ADDENDUM NO. 1
BUILDING DEMOLITION AND ASBESTOS ABATEMENT FOR
RISEDORPH TANNERY BROWNFIELD PROJECT

MAY 1, 2002

ASBESTOS ABATEMENT DRAWING

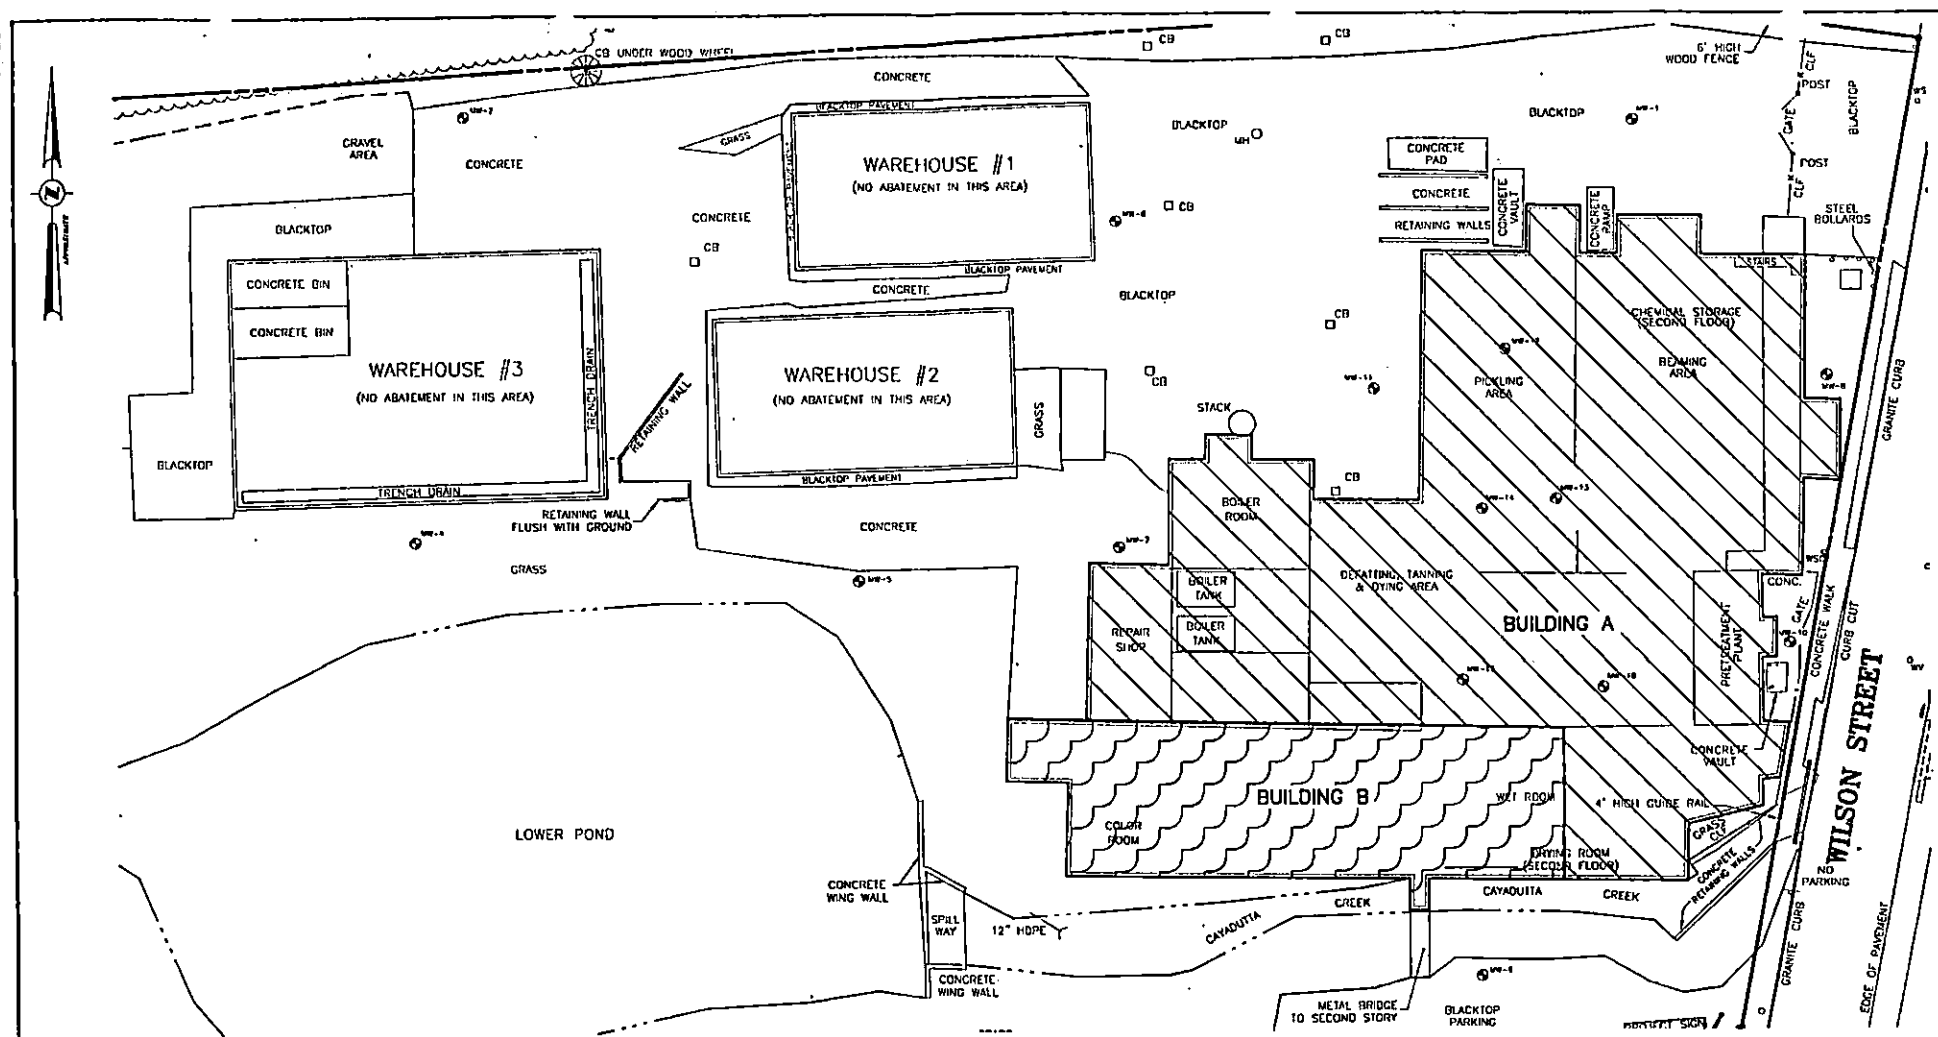
- A. No changes have been made to the plans.
- B. The plans provided are drawn approximately to scale. Drawing C-1 has a scale bar which shows a scale of approximately 1-inch equals 60 feet. The text which reads $1''=30'\pm$ underneath the scale bar is in correct and should $1''=60'\pm$. Drawing C-2 has a scale of approximately 1-inch equals 40 feet.
